Al-Muslim Washing Ltd. & Al-Muslim Garments Accessories Ltd.

14 No. Gedda, Karnapara, Ulail, Savar.
(23.8276, 90.2586)

24th February & 29th March 2021

Observations

Anchorage details of the rebar

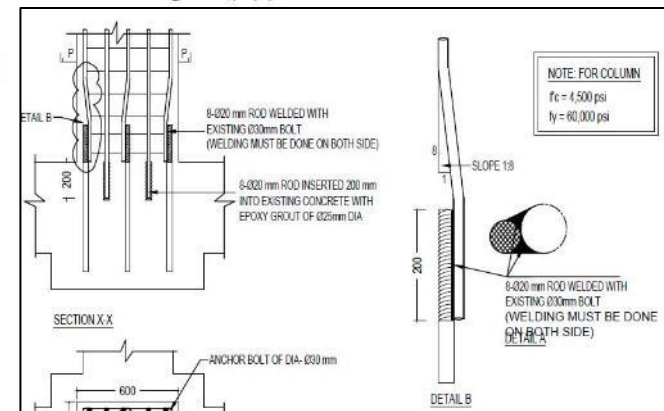
Adequacy of the rebar anchorage need to be checked

Building was initially design for the steel shed but eventually it is constructed 4-storied RCC building. Main rebars are anchored with the royal bolts. Building engineer is required to check whether the main rebar from ground floor to top floors are sufficiently having development lengths and anchorages.

Development length of the main rebar

Ground floor layout plan

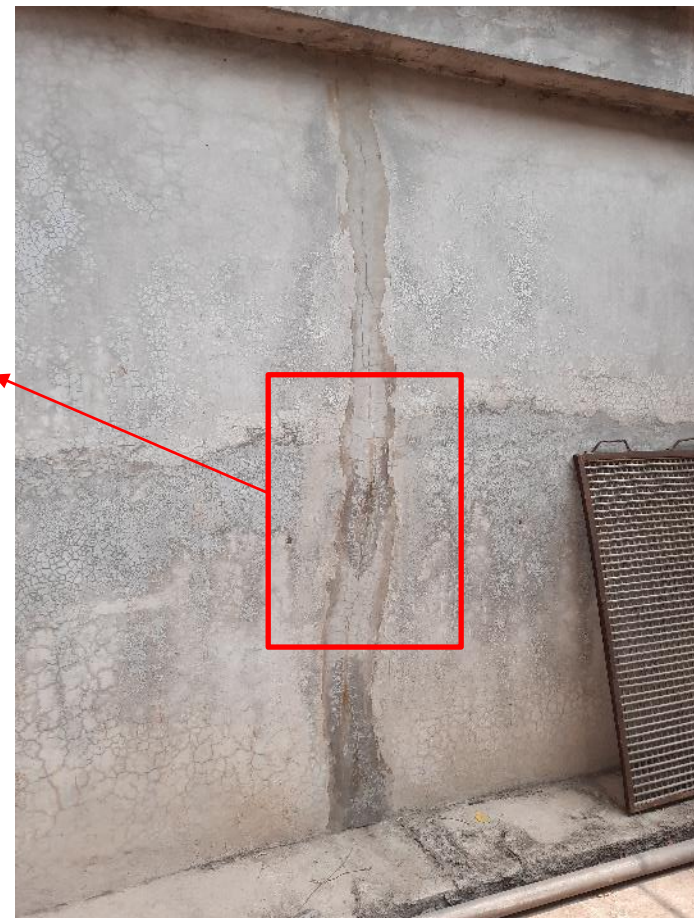
Water leakage & crack on the retaining wall

Water seeping and formation of cracks

Formation of vertical cracks

Water seeping observed through the retaining walls. Building engineer is required to investigate the cause of the water ingress and check whether the retaining walls have sufficient structural capacity. Also check the extent & formation of the cracks.

Electrical cable hole

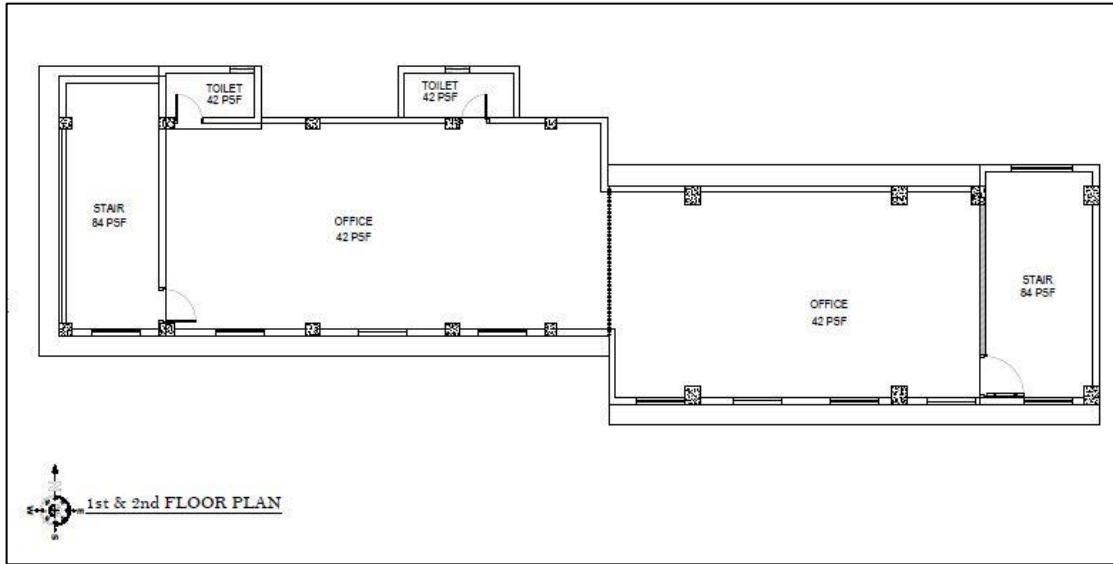
Electrical cable hole on columns

Hole of 250mm (L) X 80 mm (W) X 150 mm (T)

Electrical cables holes are made on columns. Building engineer to Investigate and report on this matter to verify the structural integrity of the columns are not compromised.

Floor load plan prepared considering 2 kPa (42 psf) for building 1

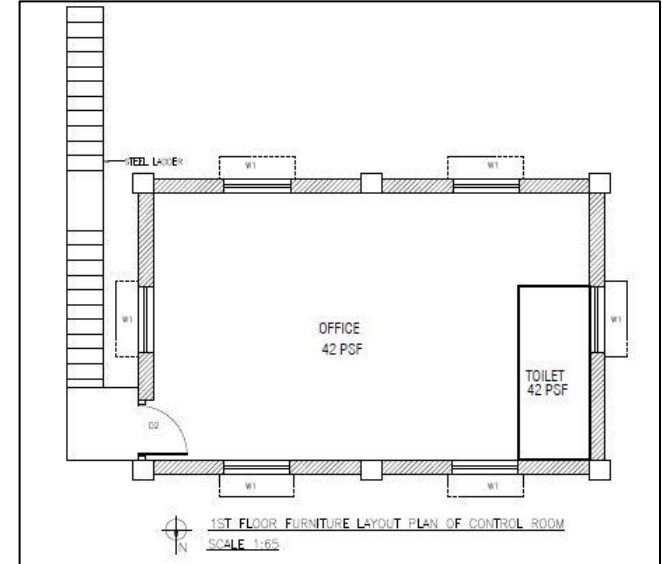
Load plan not comply BNBC

The load plan of building 1 & 4 was prepared as per the NTPA guideline. BNBC minimum floor loading not followed. Building engineer is required to prepare a load plan considering BNBC.

Ground bearing capacity table

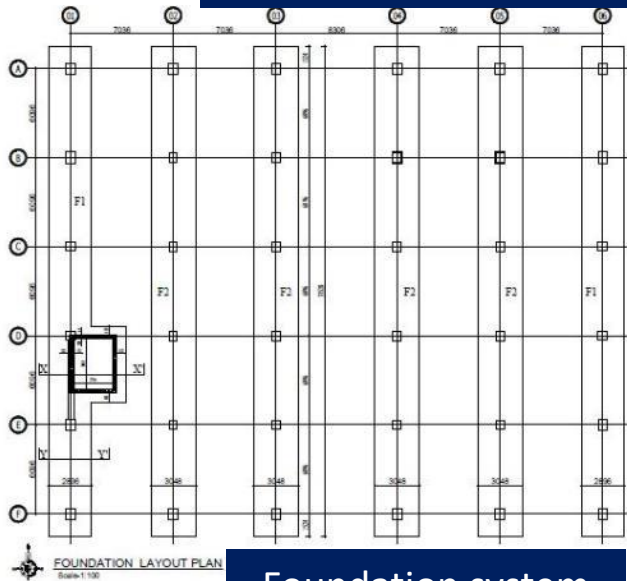
**Ground bearing capacity & foundation adequacy
to be reviewed**

The geotechnical investigation report recommends pile foundation. The foundation system of the building is combined footing. The ground bearing capacity for the isolated footing varies a lot for BH to BH (13.93 ton/m² to 3.8 ton/m², FS 3) in the geotechnical investigation report. If the lowest value considered the footings are found stressed above normal design limit. Building engineer is required to check the considered ground bearing capacity & foundation adequacy.

No-engineered extension at East side

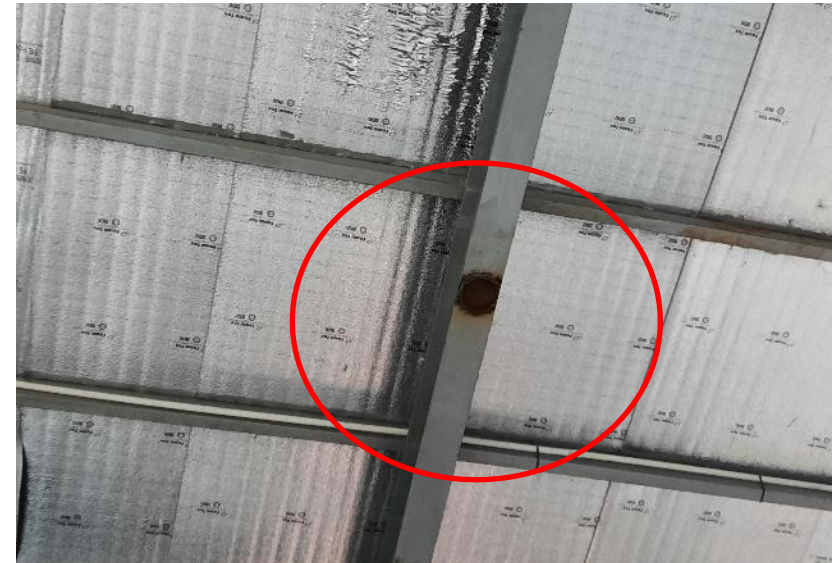
An extension of the shed was observed on the East side. The structural system of the extension is non-engineered. Building engineer is required check the structural integrity and adequacy of the non engineered extension of the shed.

Corroded purling & damaged rafter

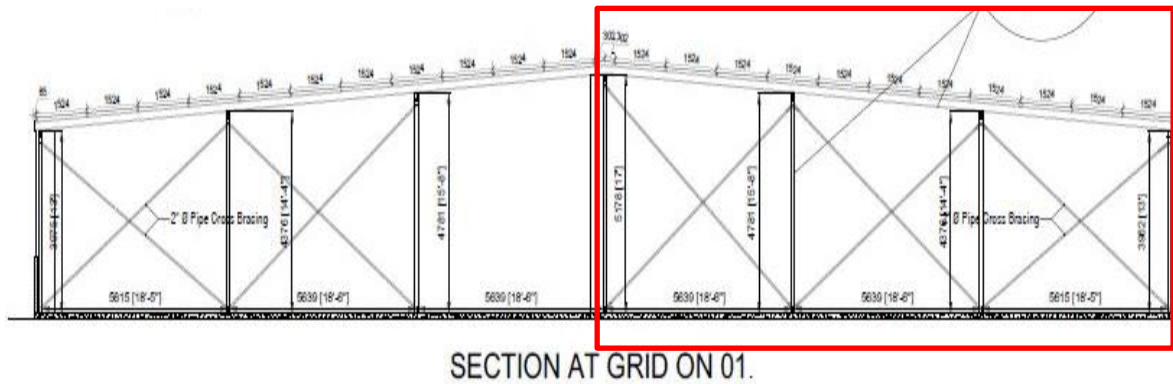
Corroded roof purlin

Some damaged rafter observed
